PD Modification Application:

PRS 22-1267

**Hillsborough
County Florida**

Development Services Department

Proposed Site Plan: Close-up of Proposed Temporary Access Area

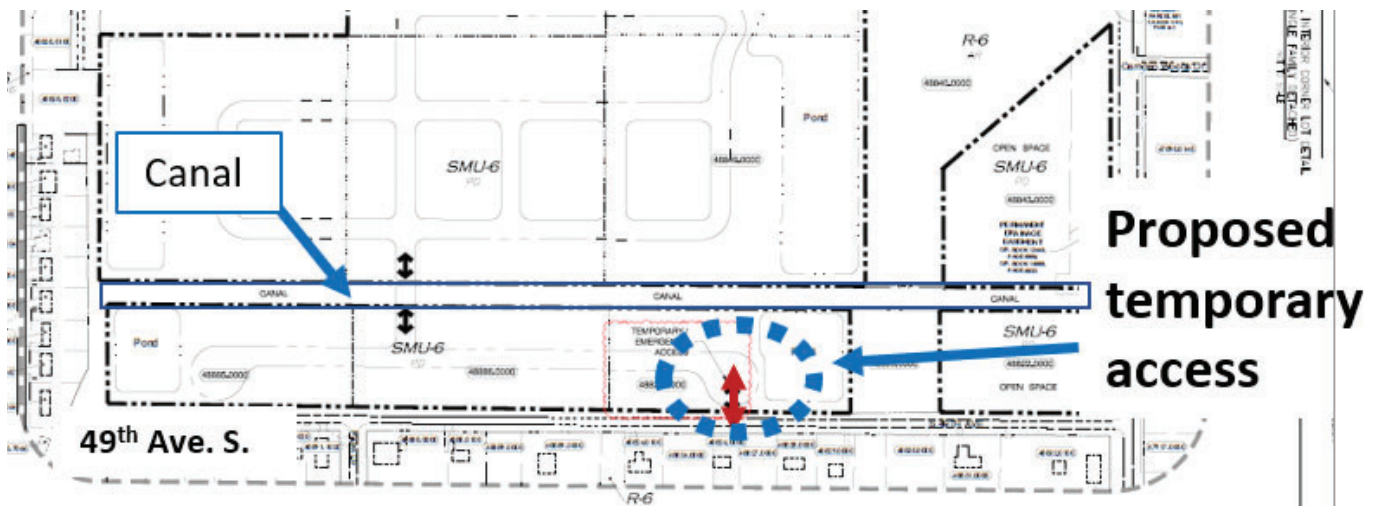
The modification is to allow construction of a temporary access connection to 49th Street for a period of time not to exceed 6 months from the date of the first homesite within Phase 6 receiving a certificate of occupancy. Thereafter, the request proposes to convert the temporary access to a gated emergency access.

According to the applicant's narrative, "Touchstone Phase 6 has been subdivided for 71 single-family detached units with homesites currently under construction. Phase 6 is separated from remainder of the Touchstone Subdivision by a substantial open drainage ditch. Upon final completion, primary access to homesites within Phase 6 will be via a steel bridge that will span the open drainage ditch and provide a connection to Summer Savory Street. The application further states that due to supply chain and fabrication issues beyond control of developer, Lennar Homes, the steel bridge will not be installed and certified before homesites within Phase 6 are completed."

Prior to PD site plan certification, the applicant shall revise the PD site plan note "TEMPORARY/EMMERGENCY ACCESS" to state "TEMPORARY ACCESS/EMERGENCY ACCESS/PEDESTRIAN ACCESS – See Conditions of Approval".

8.2 Proposed Site Plan

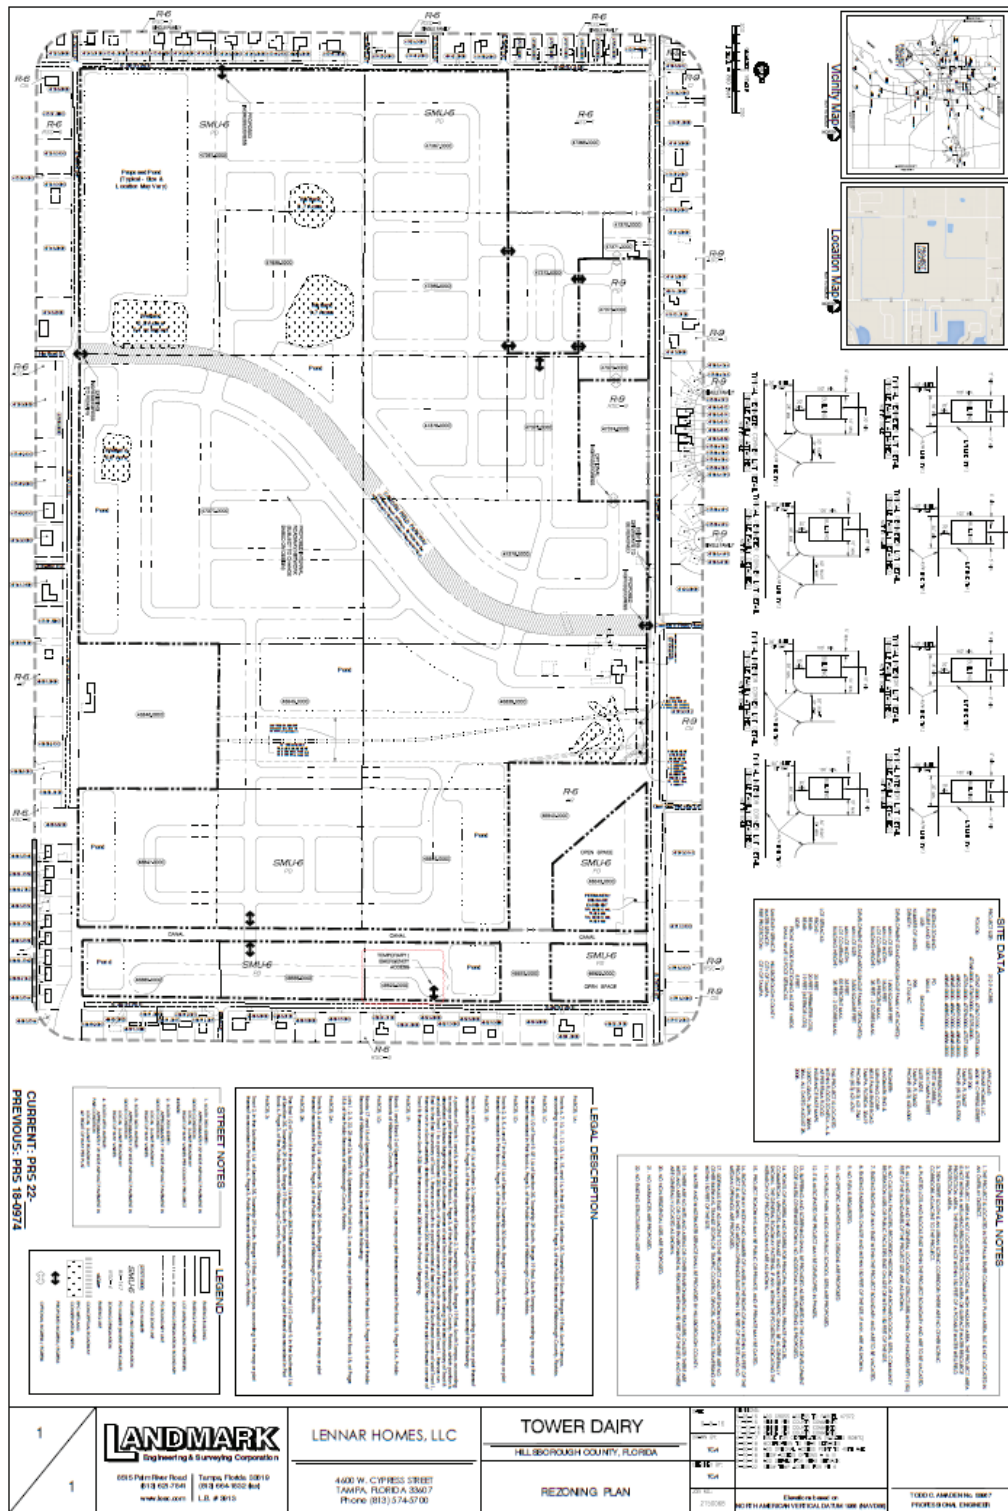
- Prior to PD site plan certification, the applicant shall revise the PD site plan note "TEMPORARY/EMERGENCY ACCESS" to state "TEMPORARY ACCESS/EMERGENCY ACCESS/PEDESTRIAN ACCESS – See Conditions of Approval".

The applicant shall be required to construct a 5-foot sidewalk along the project frontage on South 49th Street and provide a pedestrian connection from the project's internal local roadway to South 49th St. The proposed conditions of approval memorialize said requirement. Additionally, staff is requiring that, at the time of PD site plan certification, that the applicant revised the site plan to add a note that the pedestrian access to South 49th St. is required.

- 22.1 One (1) full access to 49th Avenue South shall be permitted in the location shown on the General Site Plan on a temporary basis only while a connection from Phase 6 to Summer Savory Street is being constructed. The temporary access connection (a) shall be constructed by developer at its sole cost and expense, and (b) shall not be used for a period of time exceeding six (6) months from the date the first unit in Phase 6 is issued a certificate of occupancy.
